TOWN OF GLASTONBURY
GL-2017-26
LOCKER ROOM RENOVATION GLASTONBURY PD
ADDENDUM NO. 2
May 9, 2017

Bid Due Date: 05-11-17 @ 11:00 A.M.

1 LOCKER SECTION

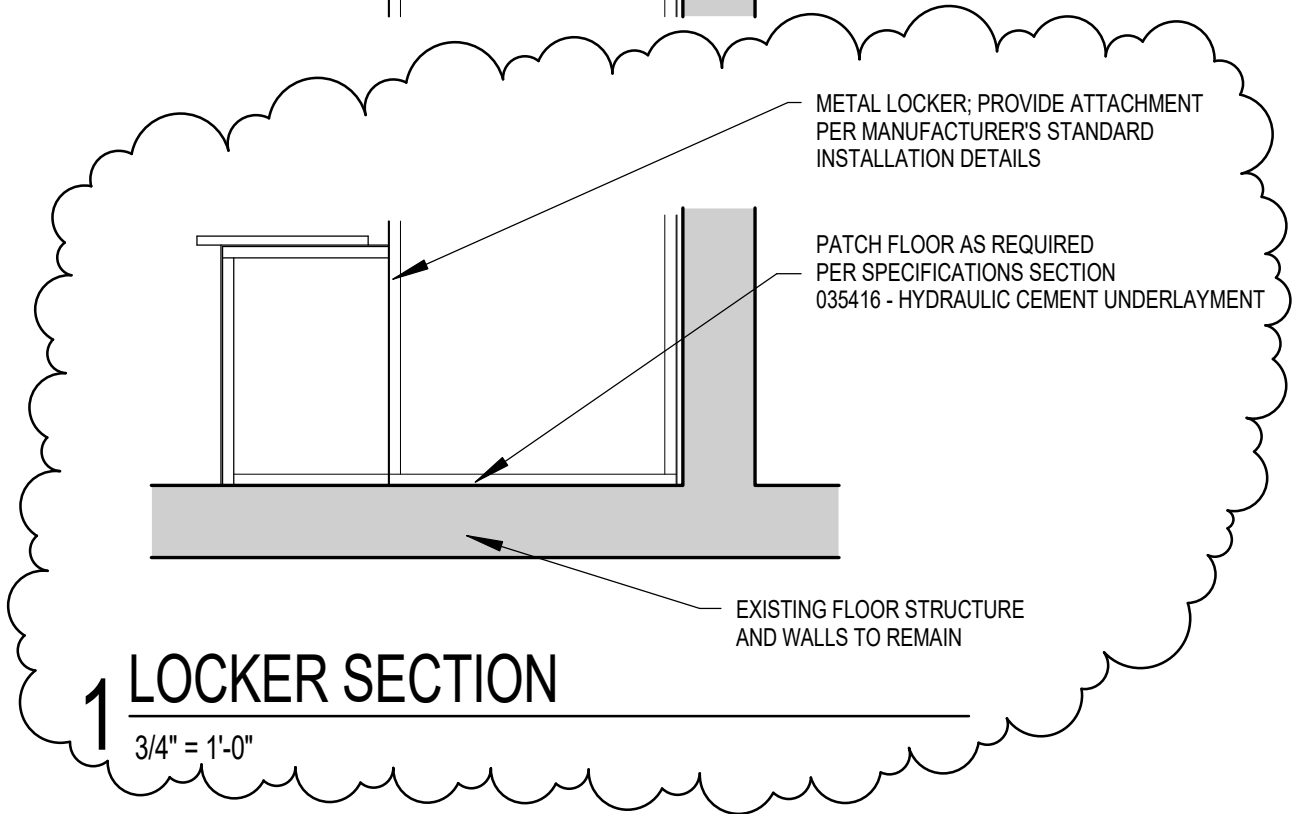
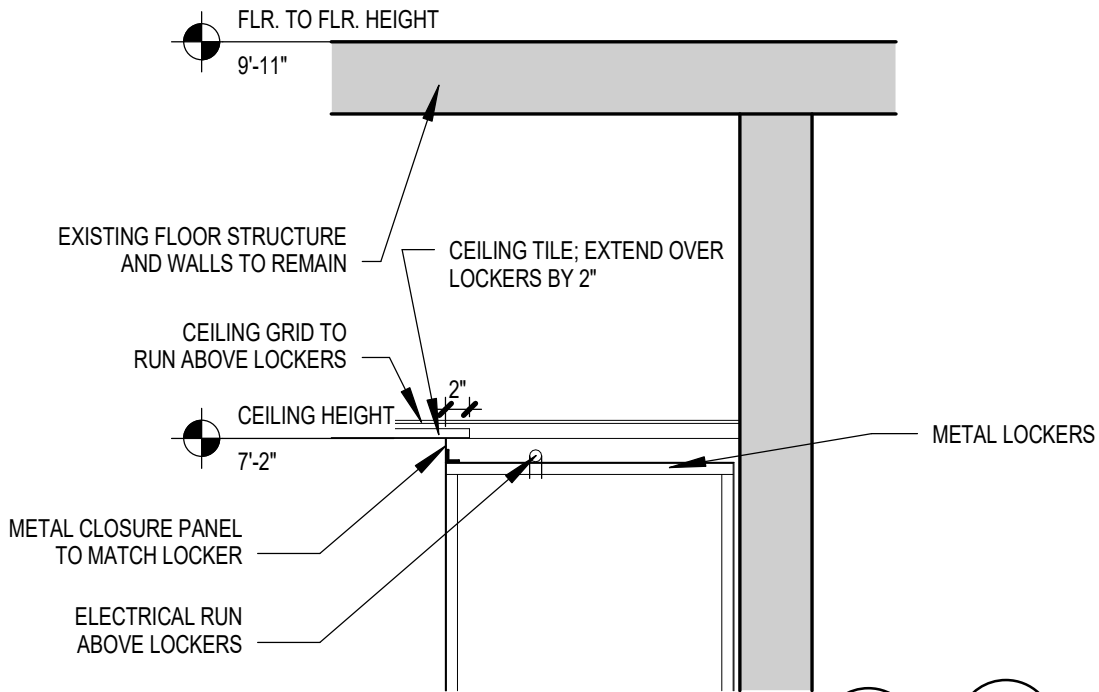
Question 1: It is unclear how to address the flooring after the CMU locker bases are removed?

Answer: Existing floor finish and locker bases are to be demolished per Specification Section 024119- Selective Demolition. Patch sub-floor per Specification Section 035416- Hydraulic Cement Underlayment. See attached SKA-1.
